DATE: April 14, 2009

## Addenda No. 1

SUBJECT: US101: Neahkahnne Mountain Rock Wall Repair Section  
Oregon Coast Highway  
Tillamook County  
Grading, Drainage, Structure, and Paving Project  
(Bids to be opened and read April 23, 2009)

<b>OREGON DEPARTMENT OF TRANSPORTATION</b>	
<b>REGION 2 TECH CENTER</b>	
US101: NEAHKAHNNIE MOUNTAIN ROCK WALL REPAIR OREGON COAST HIGHWAY TILLAMOOK COUNTY	
Design Team Leader - Carol Cartwright Designed By - Bob Bakonen Drafted By - Karen L. Wright	
<b>DETAILS</b>	SHEET NO. <b>2</b>

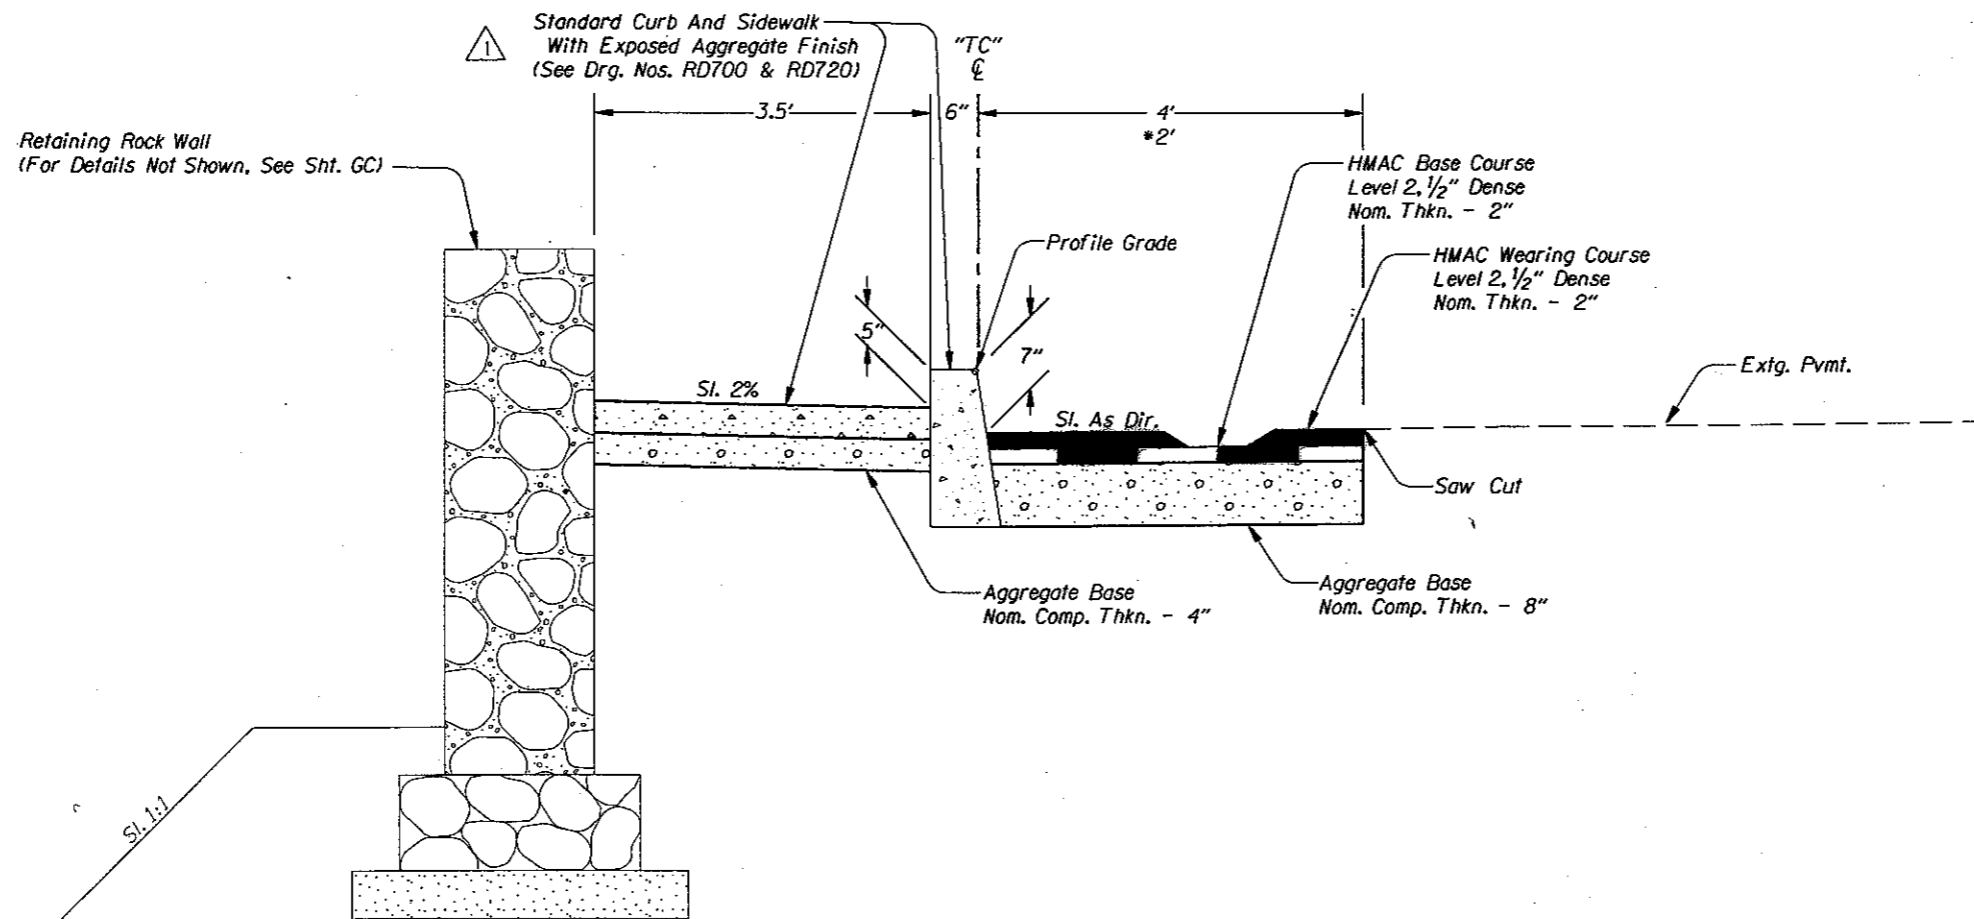
Revised 04-15-2009  
 Changed Note

SHEET NO.  
2B-3

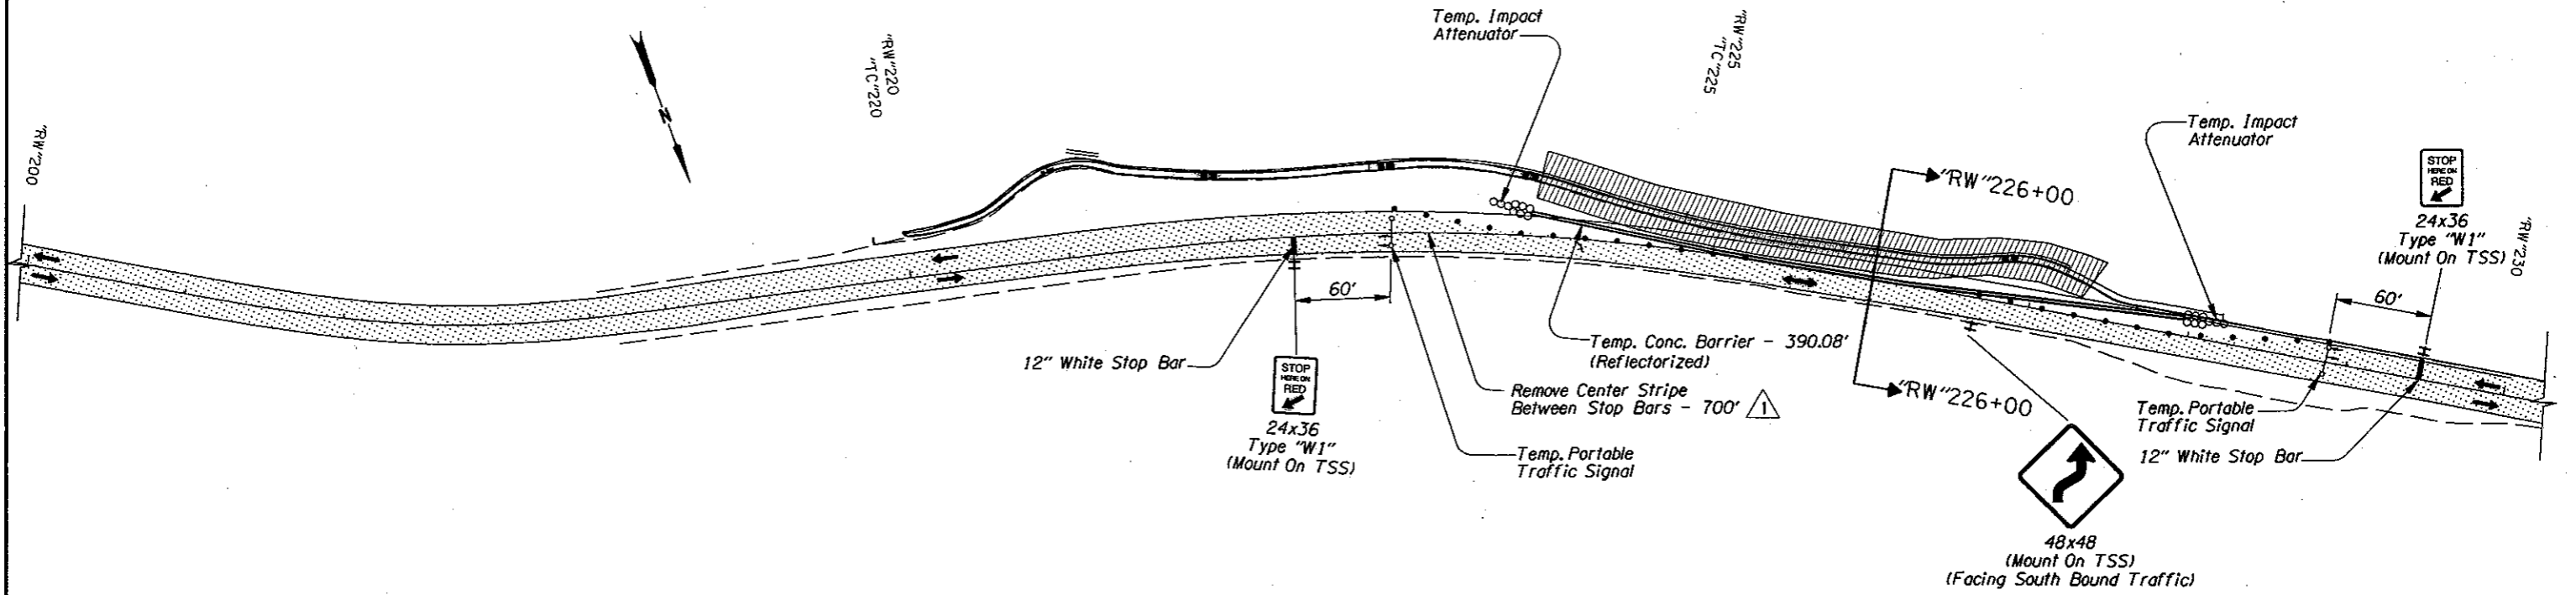
▲ Revised 04-15-2009  
Added Note

For Section "RW"226+00 Details,  
See Sht. 2B-4
